JOB TITLE:
PROPOSED BLUE SKILLS TRAINING FOR EMPLOYMENT CENTRE (BSTEC) FOR THE KISUMU NATIONAL POLYTECHNIC ON KISUMU MUNICIPALITY / BLOCK 9 / 101

DRAWING TITLE:
SITE PLAN

P-150	DRG. NO: 01	REVISION:	DRAWN BY: J.O.O.
	SCALE: 1:300	DATE: MAR 2026	CHECKED BY: O.M.

DRAWING TITLE:
WORKSHOP 2 - SECTION D-D' RESTAURANT - ROOF PLAN, PLAN, ELEVATION 22

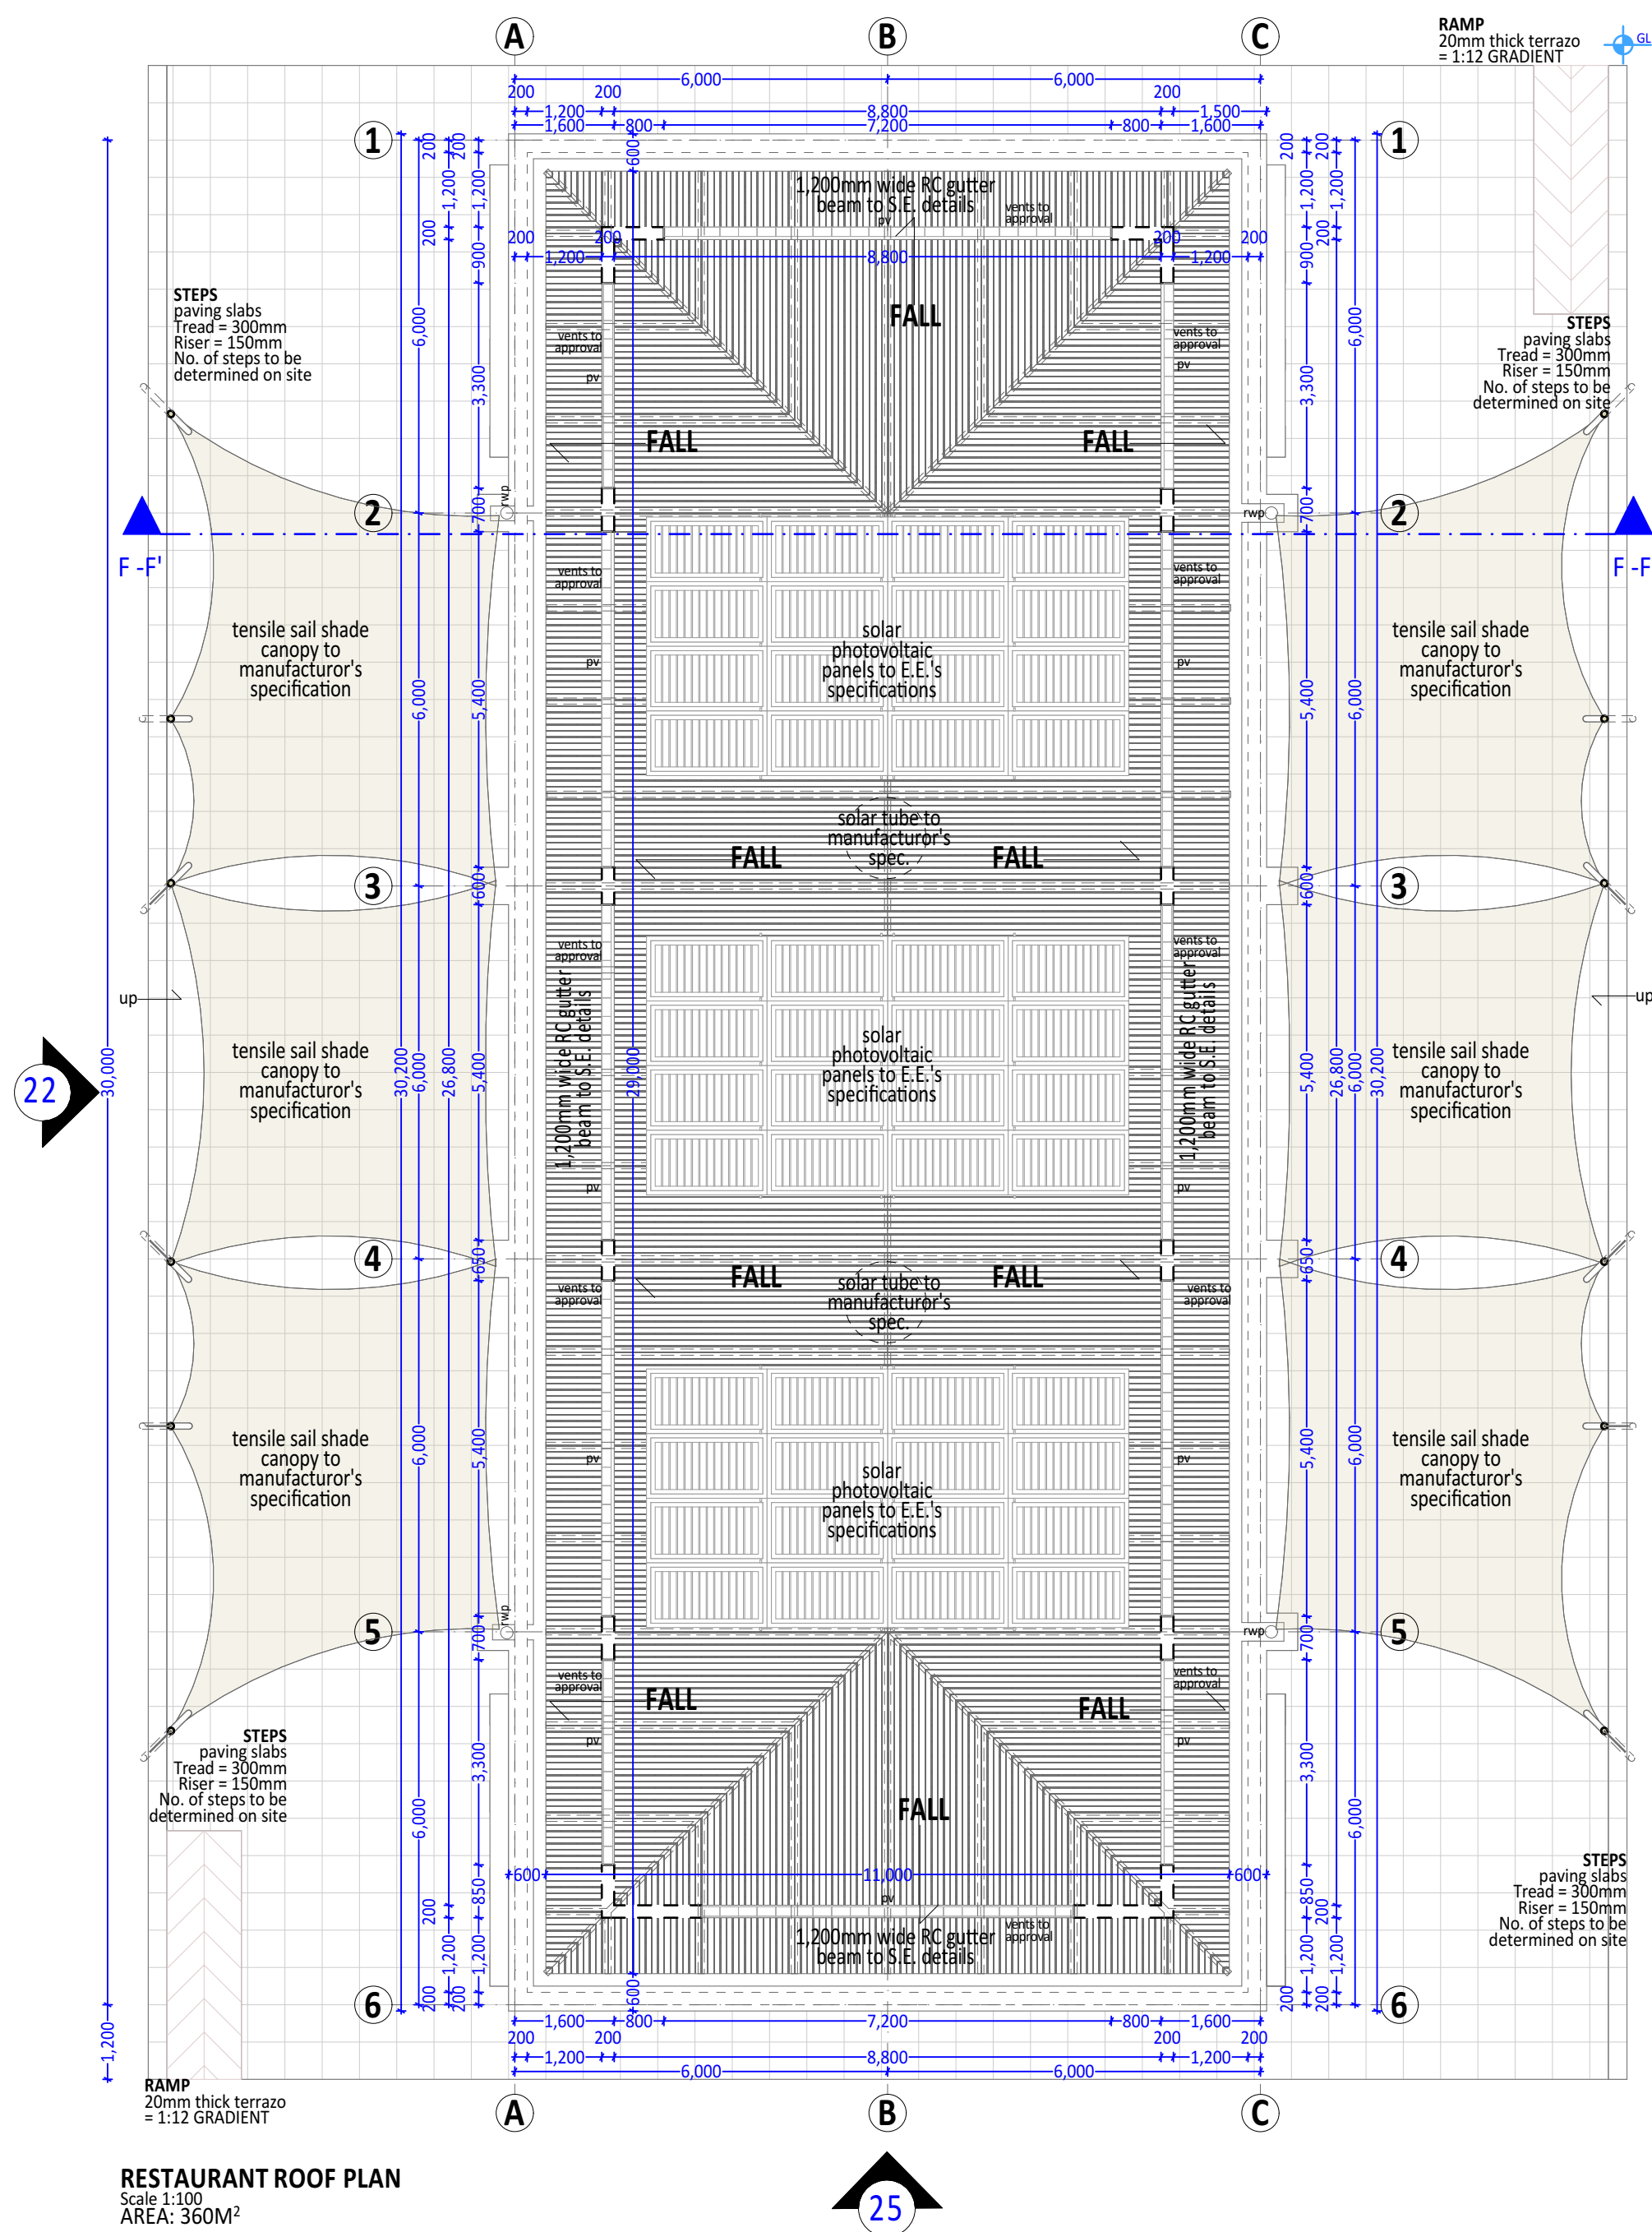
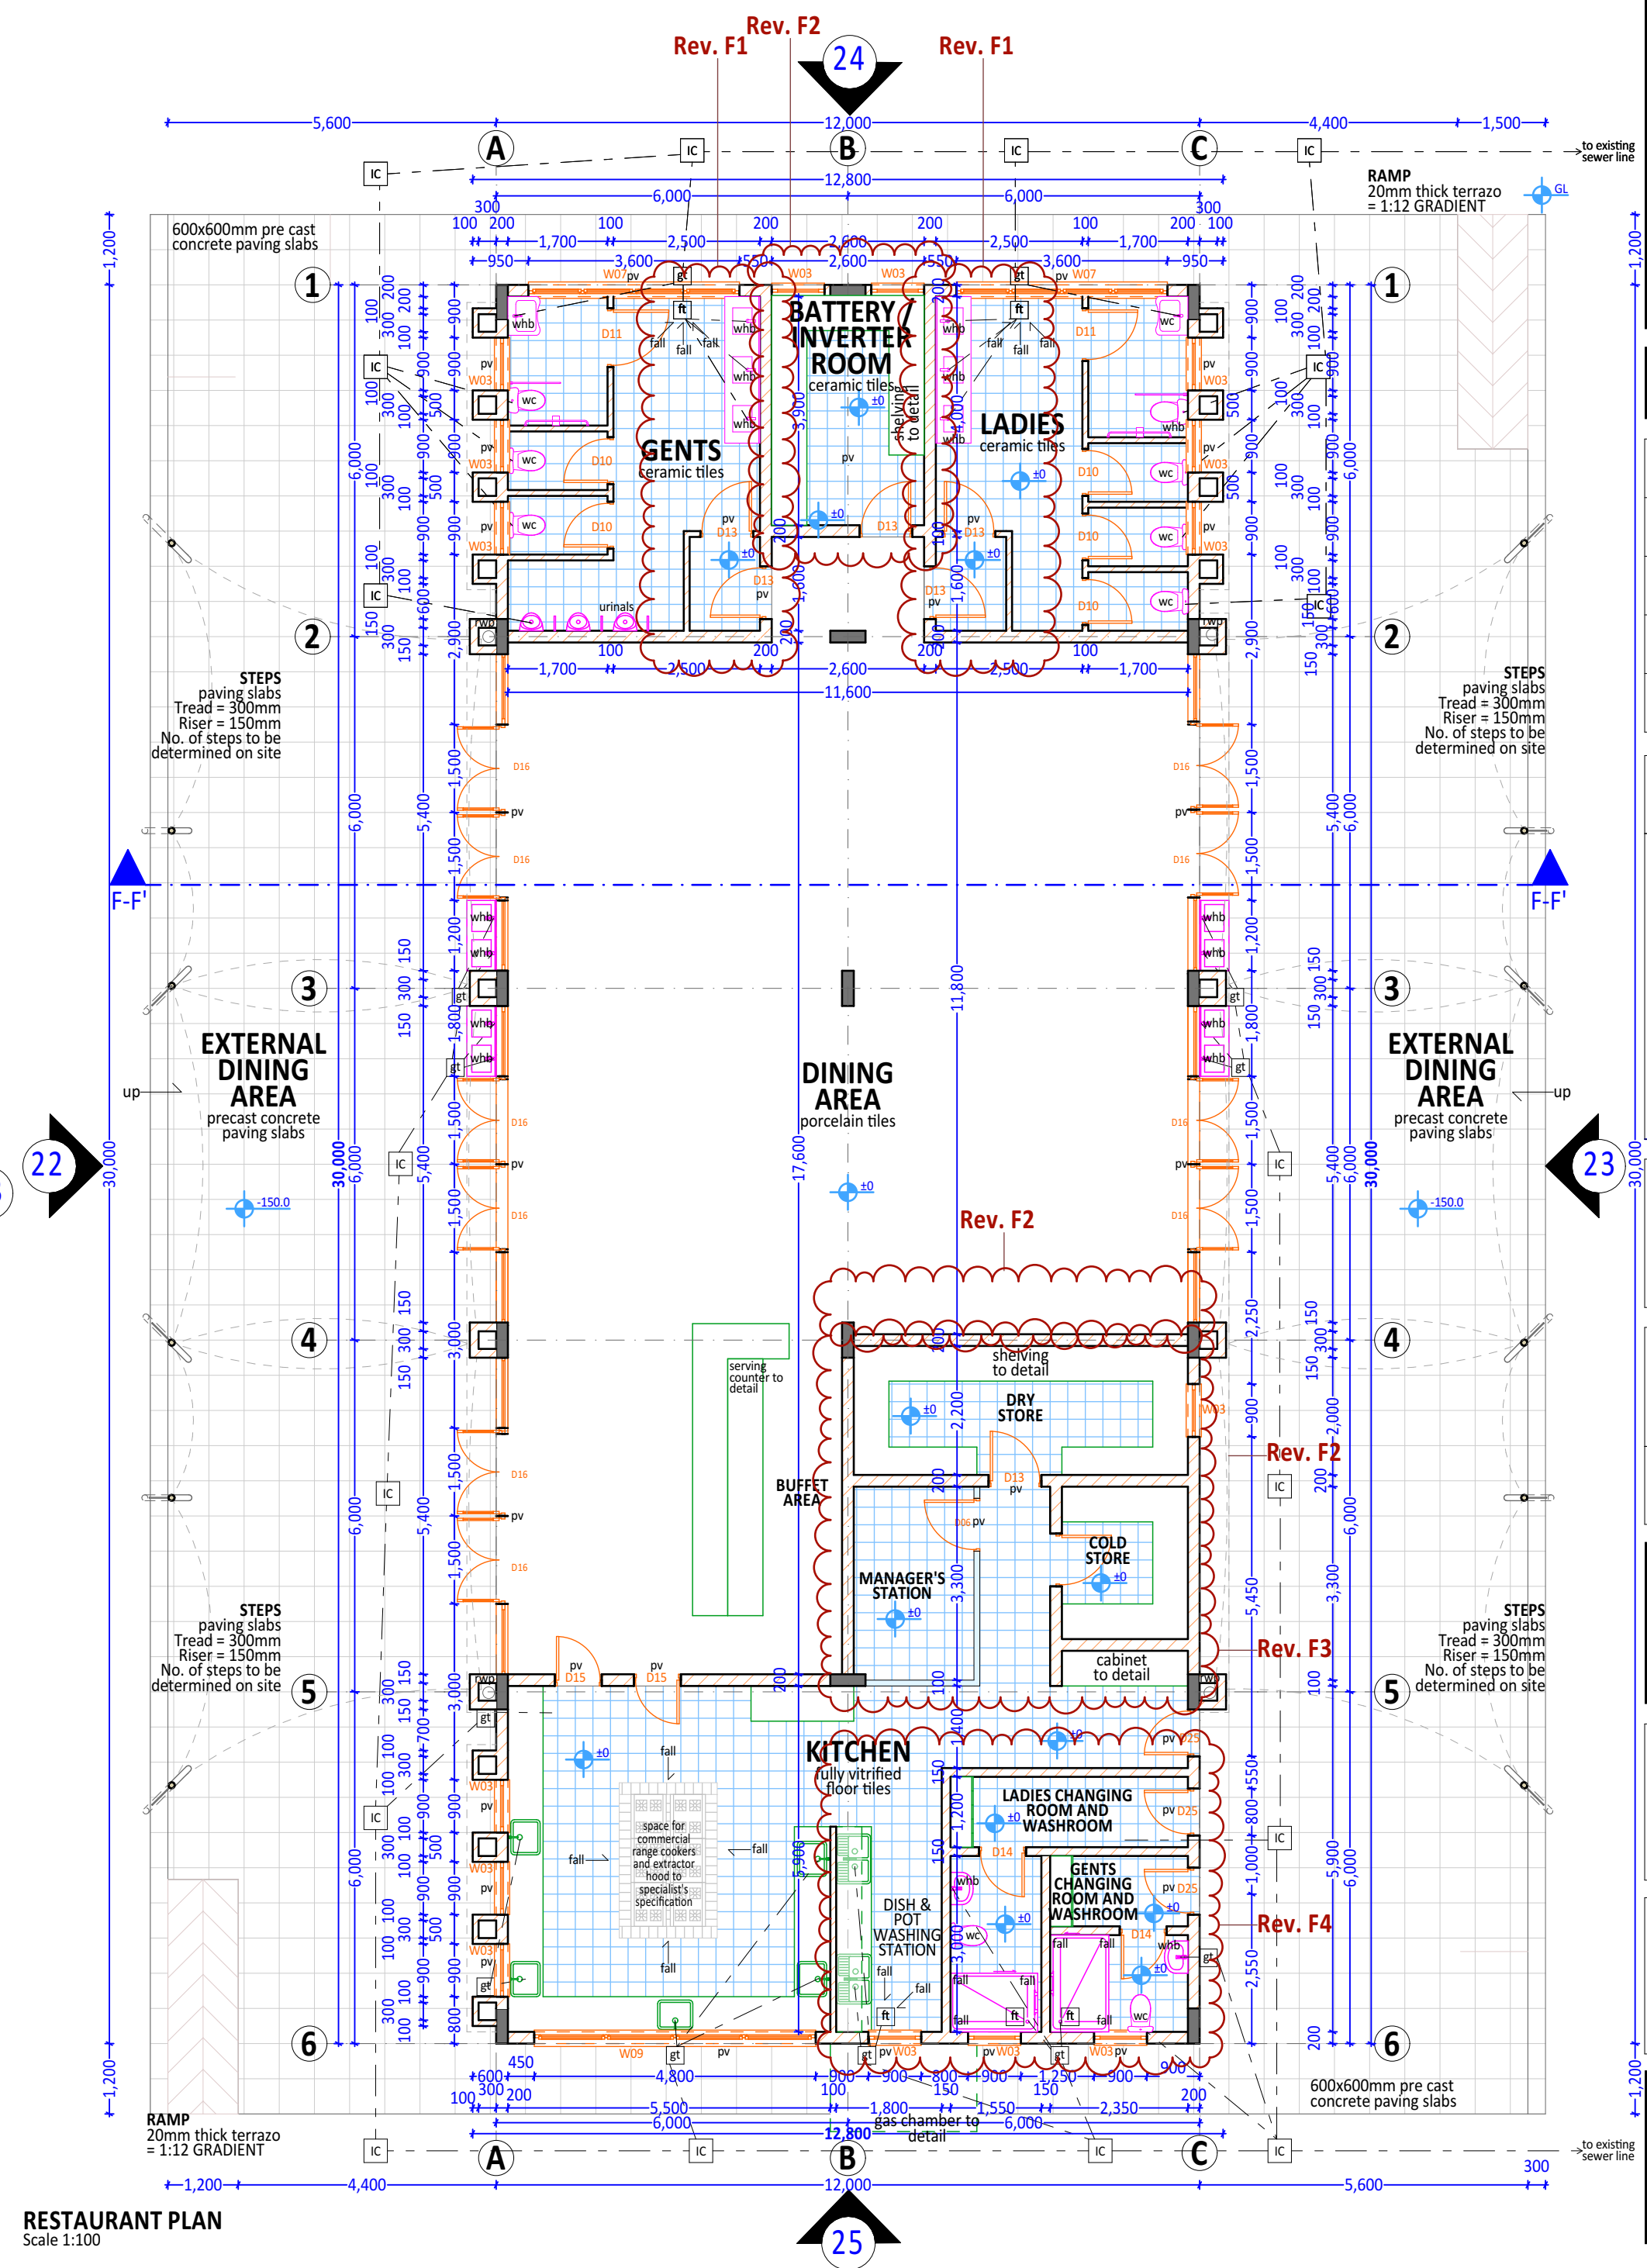
No.	Date	Revision/Issue
Rev. F1	15/06/26	Separate vestibules introduced to access washrooms and battery / inverter room from inside the restaurant
Rev. F2	15/06/26	Wash hand basins introduced
Rev. F3	15/06/26	Manager's Office introduced by reducing sizes of cold store and dry store and omitting general store
Rev. F4	15/06/26	Changing rooms introduced in the staff washrooms

ADMINISTRATION BUILDING PLAN
Scale 1:100

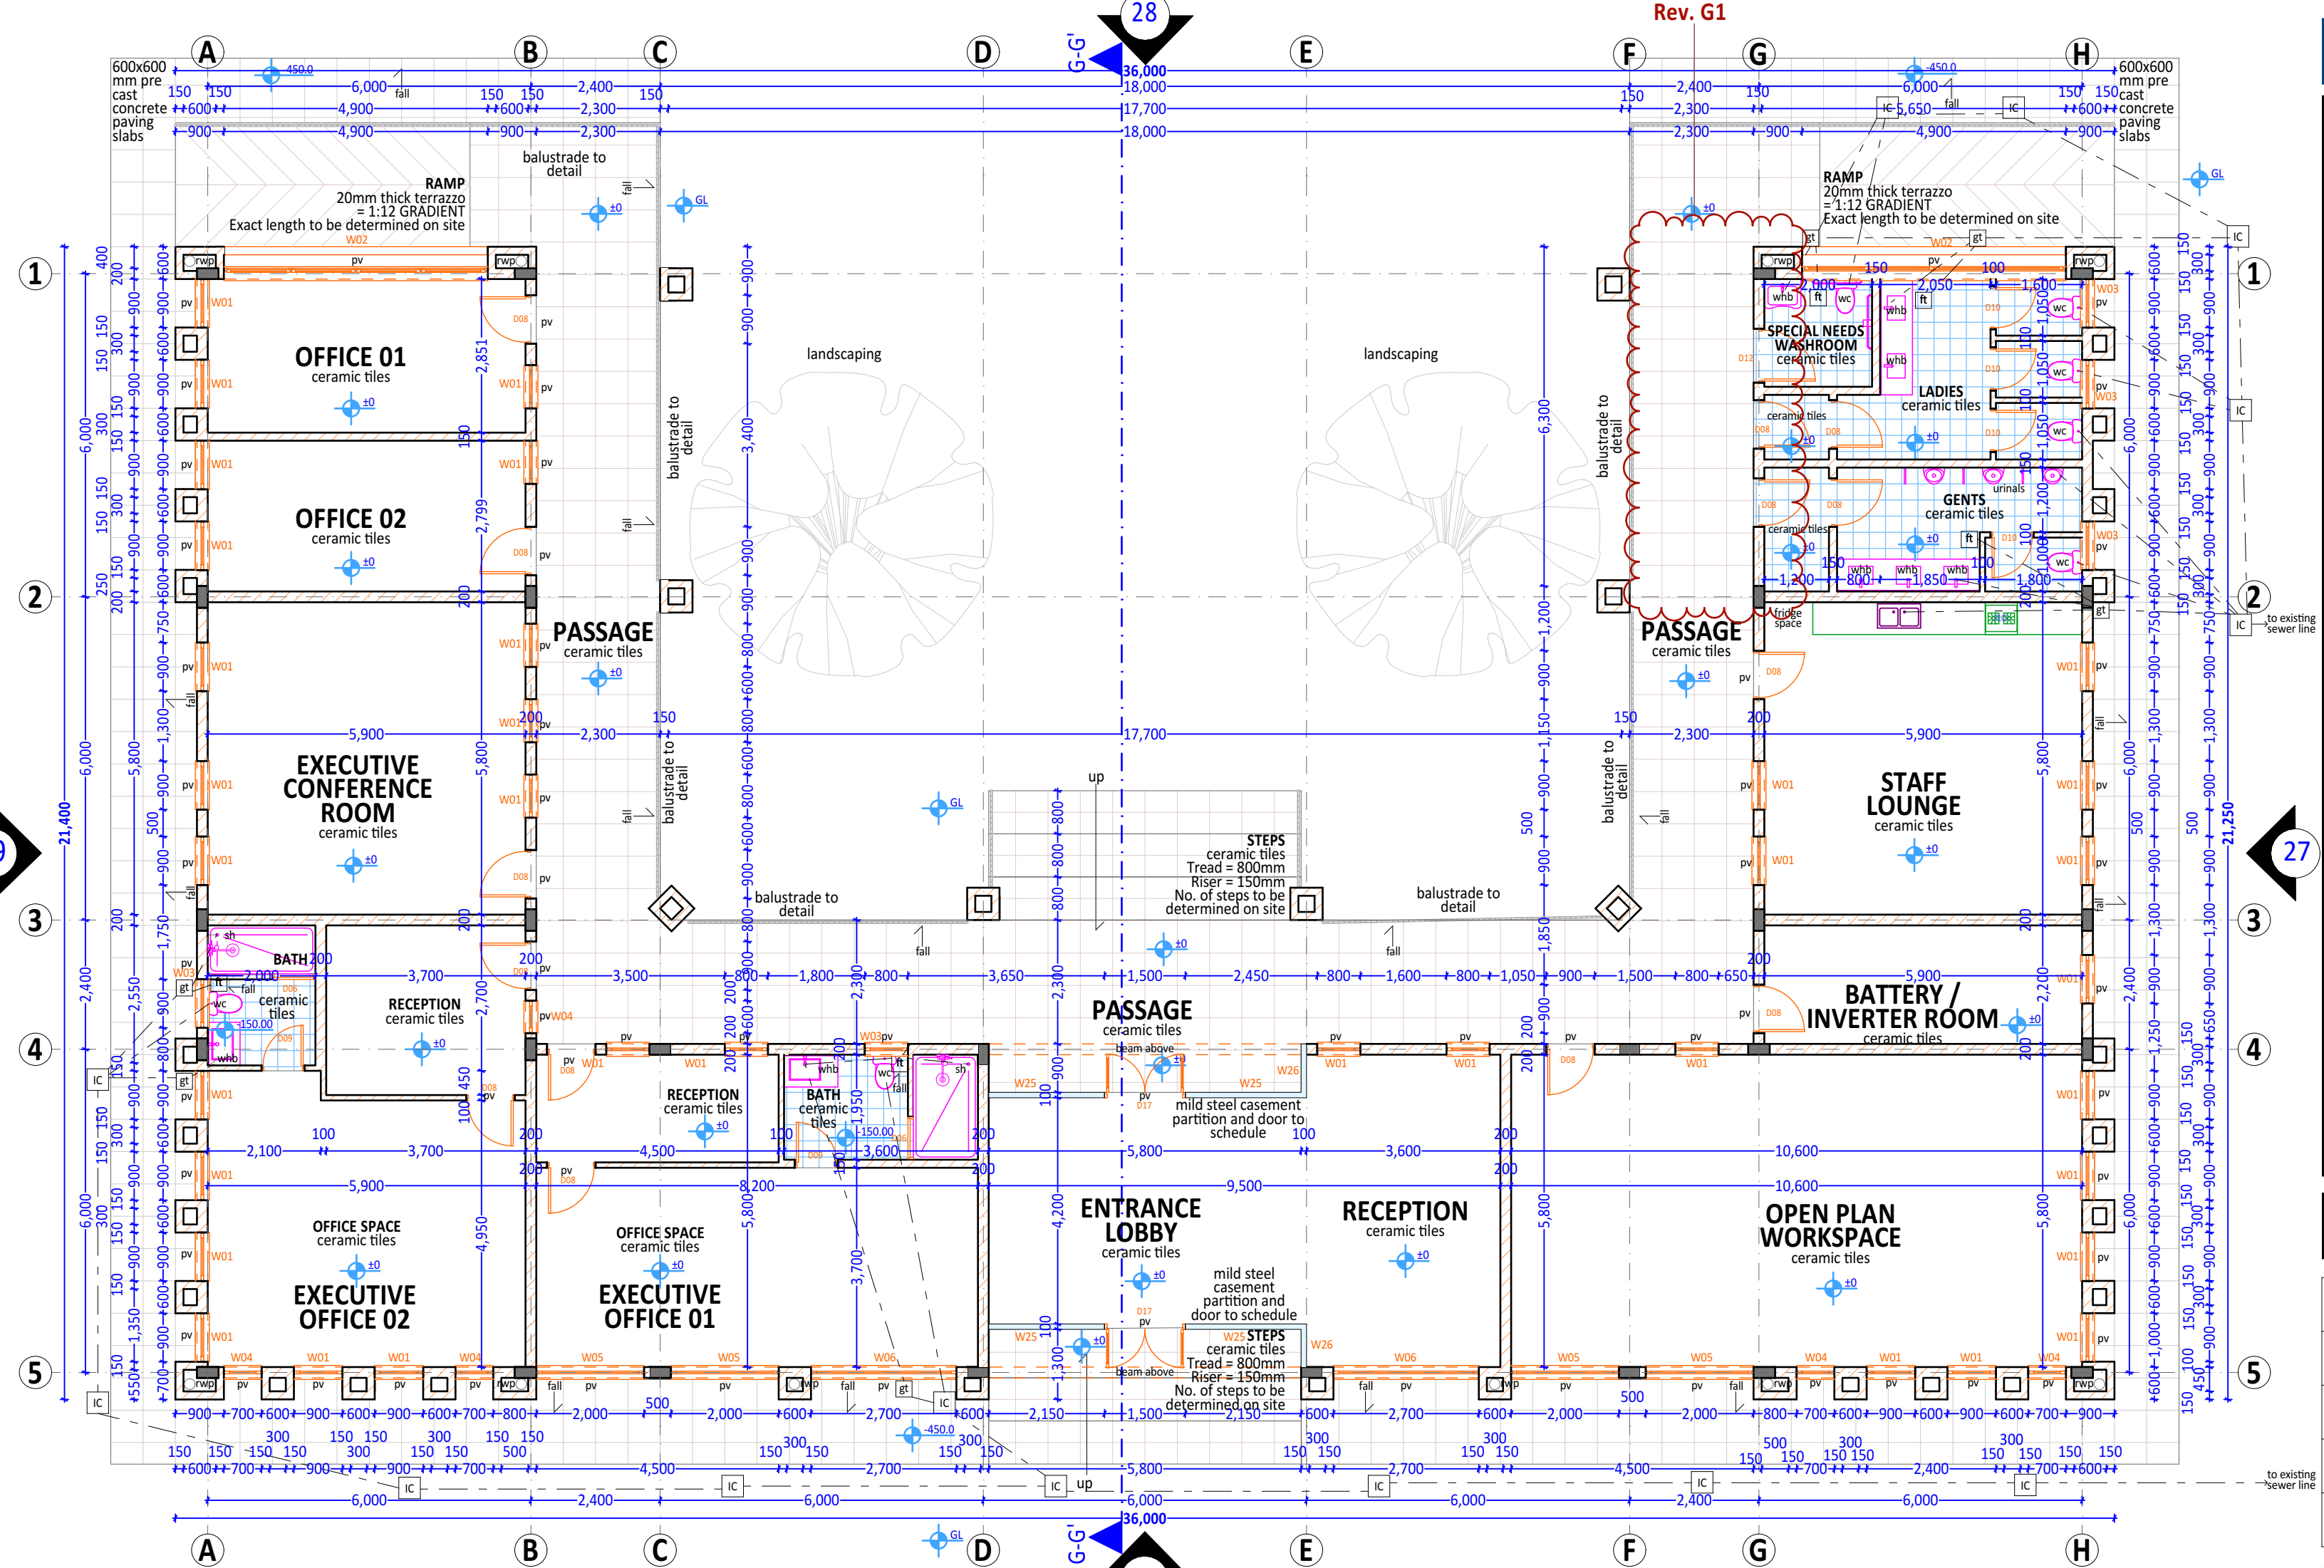
No.	Date	Revision/Issue
Rev. G1	15/06/26	Ladies, Gents, Special Needs Washrooms have separate vestibules.
